To all users of the following systems: Cios VA30

|                     |  | Corrective Action ID | AX036/23/S   |

## Customer Safety Information (CSI) for Field Safety Corrective Action

**Subject: Fulfillment of new requirements from DIN and IEC standards for Cios VA30 Systems**

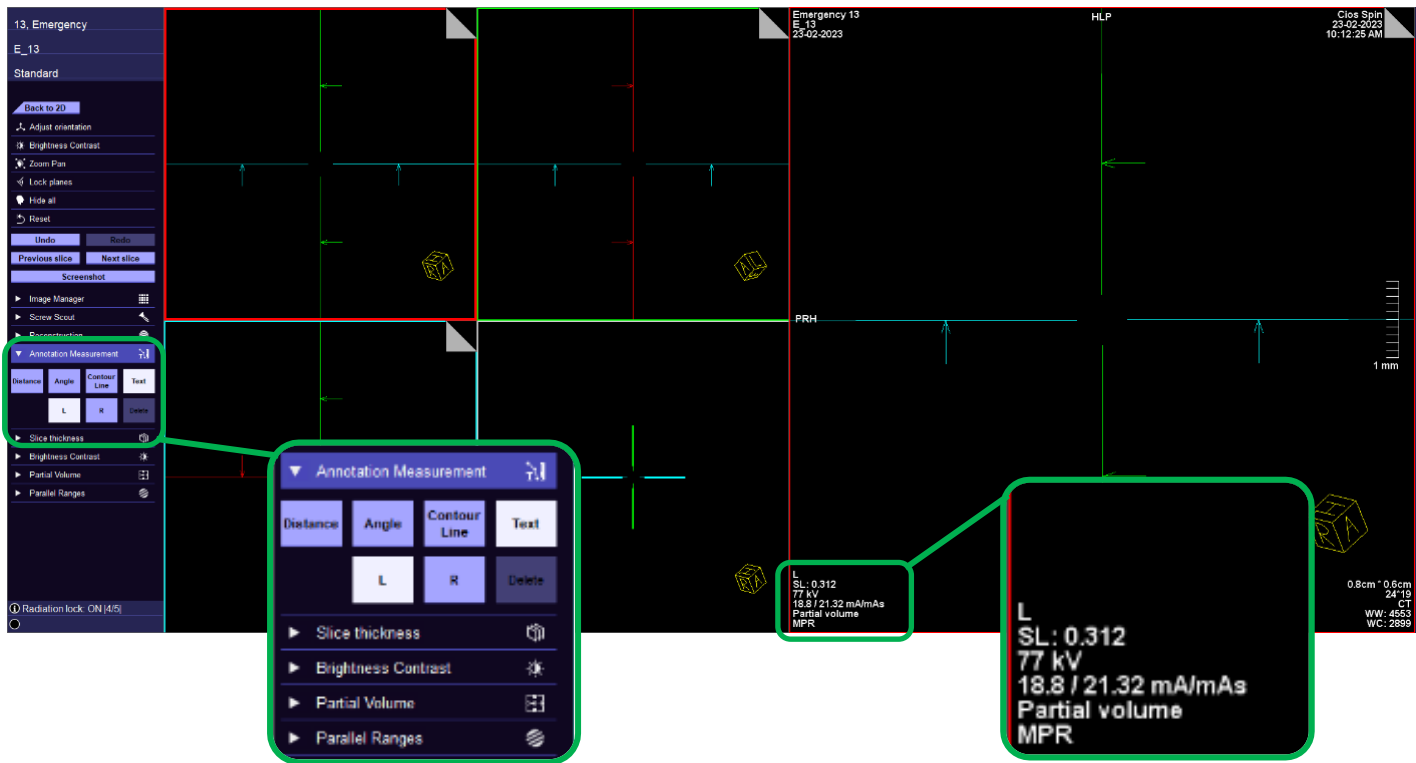
In 3D mode and if patient orientation information is important in a procedure, the user can predefine the patient orientation “L/R” (left/right), and therefore “laterality” information will additionally be saved in the clinical image (see screenshot of user interface below).

With software version VA30K, the user interface of Cios VA30 systems will be changed to consider the current standards DIN 6862-3 and IEC 60601-2-54.
